# NRC DEIS HEARING

NRC DEIS Hearing  
PEF Levy Nukes 1 & 2  
Crystal River, Florida  
Plantation Inn  
9-23-10

### **Executive Summary**

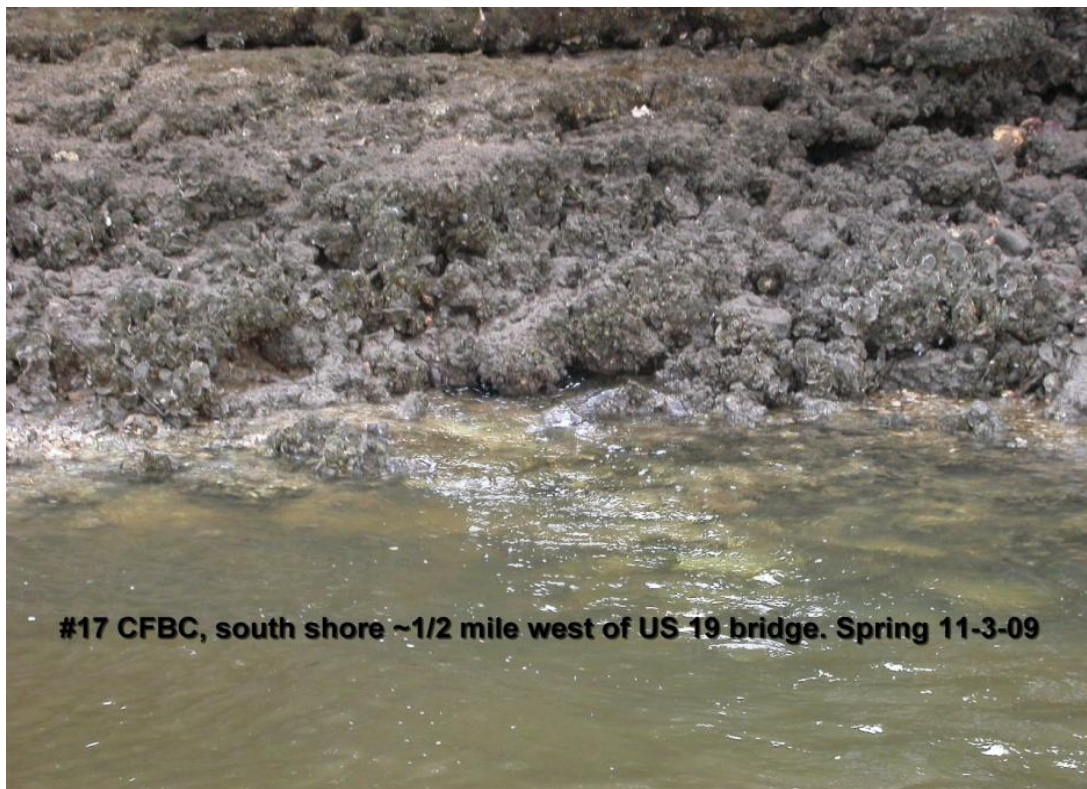
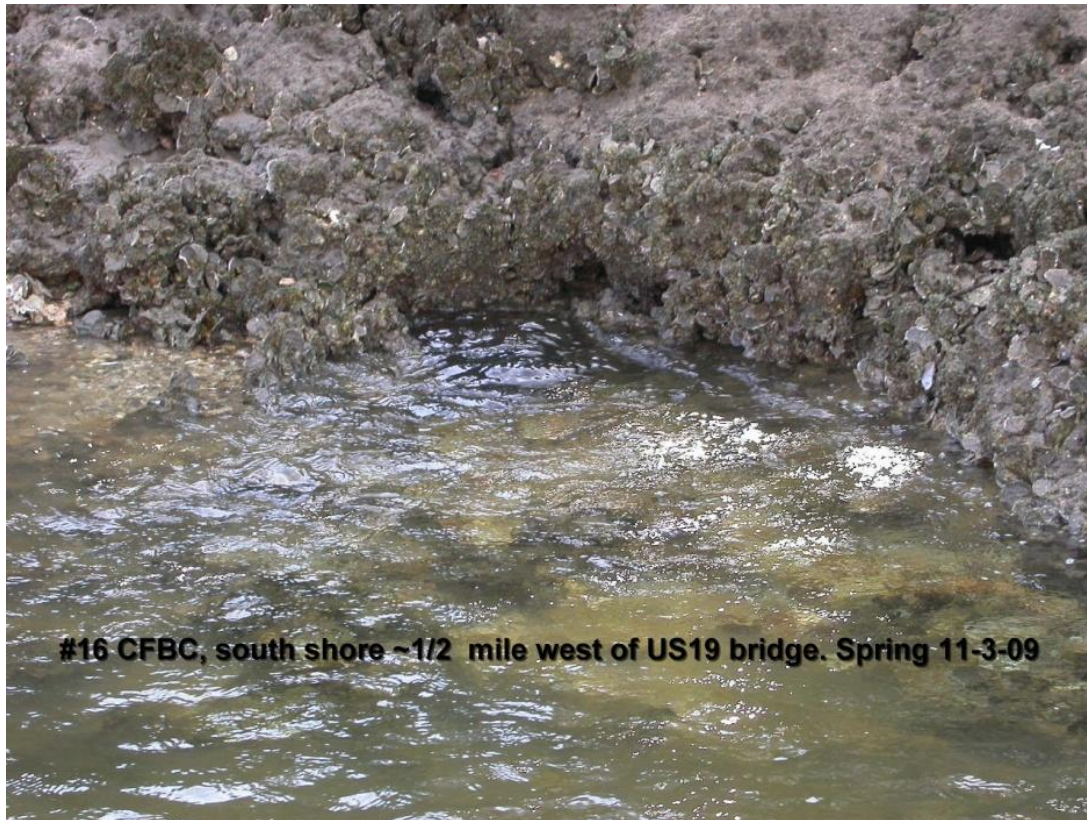
If assertions by the Applicant are correct there is additional spring flow contribution in the CFBC that is unaccounted for by the COLA and DEIS. If the Applicant is incorrect the hydrologic analysis of the CFBC is incorrect and conclusions in the DEIS are not supported. WAR is aware of spring vents visible at low minus tide scenarios that are located west of the US 19 Bridge that crosses the CFBC, or 3 - 5.6 statute miles west of the Inglis Locks. The clustered nature of these features implies that more are present yet unidentified. NRC cannot properly quantify estuarine

The following photos which represent a small portion of approximately 40 spring weeps, cascades and boils located west of the bridge and visible during low minus tides:

The location of springs as presented in the COLA is vague, as is quantification of contribution to the System as accounted for by the Applicant and NRC review. Estimates are a crude measure as compared to technology which may finely evaluate such hydrologic considerations. The technology to identify all such sources of fresh water supply to the CFBC exists in the form of airborne thermal imaging (**Attachment J-Raabe-Bialkowska-Jelinska**) for location, and Doppler technology for quantification. Such technology or variations thereof was used by the Applicant for evaluation of offshore currents. (COLA Part 3 ER, Chapter 6, 6.3.1.4)
